PINS reference TR030001

Application for the proposed Able Marine Energy Park on the south bank of the River Humber at Immingham, North Lincolnshire

Response to first stage Written Representations
in Respect of Terrestrial Ecology and
Nature Conservation

**Response to Comments on Relevant and Written Representations and 1st Round Examiner
Questions on Marine Matters**

FIGURE PW2

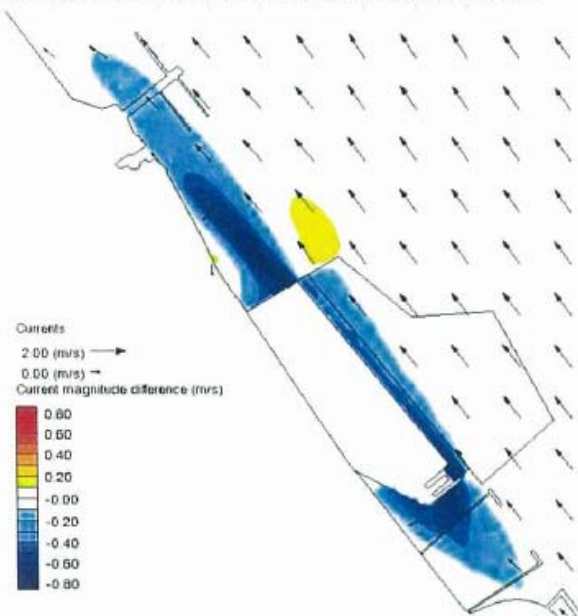
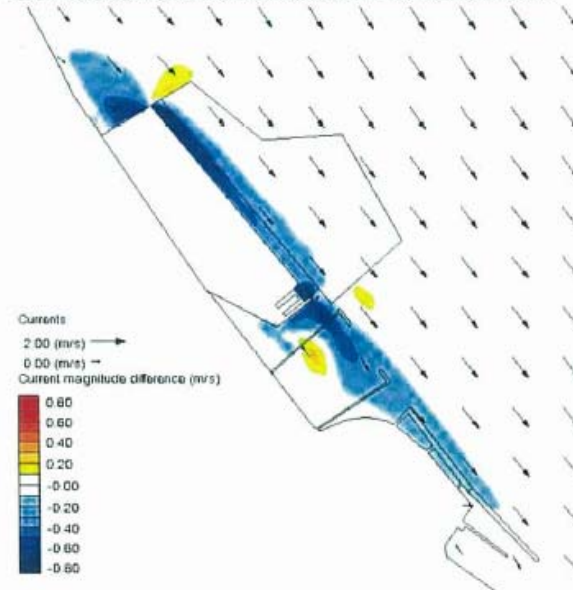
- 3.6. I observe that the applicant now notes ABP's concerns with respect to IOH. The applicant, however, still makes no comment about whether IOH was actually modelled in the baseline hydrodynamics.
- 3.7. A comparison of the June 2012 modelling results at Figures 3.9 and 3.10 of supplementary report EX 8.7 with the equivalent Figures 15 and 16 in the original ES demonstrates that IOH was not included in the original modelling. This is further substantiated by:
- Firstly, IOH was not shown or recognised as a sensitive receptor in the original ES; and
 - Secondly the pattern of change in the later modelled version is very different; see the attached Figures PW2 and PW3.

- 3.8. The argument put forward for no increase in sedimentation in IOH might be credible if the local baseline hydrodynamics had been correctly modelled and IOH had been correctly represented in the model. This does not, however, appear to be the case and the queries raised by ABP in this respect have not been answered by the applicant's response. If it had been included I would have expected to see the data from the model. This has not been provided.
- 3.9. The new report, EX8.7, is an attempt to justify the assertion that there will be no effect on IOH. However, comparison of equivalent diagrams from this new report and the original modelling presented in the ES, (Figures PW2 and PW3 respectively attached), show distinctly different

patterns of effect on the local flow regime. Figure PW2 is the new modelling with the DCO development design and Figure PW3 is the ES presented design, which was inferred in the ES as the worst case. It should also be noted that IOH and the jetty structures appear in the new modelling but are absent from the ES. This supports our view in 7.2 (b) of the Relevant Representations that the works have not been correctly reflected in the ES nor properly assessed. As I indicated in Para 1.1, I have not had an opportunity yet to determine whether the new modelling has been properly undertaken and support the assertions made about it and in particular whether it has properly assessed IOH and the jetty structures, assets that are critical to marine operations at the Port of Immingham.
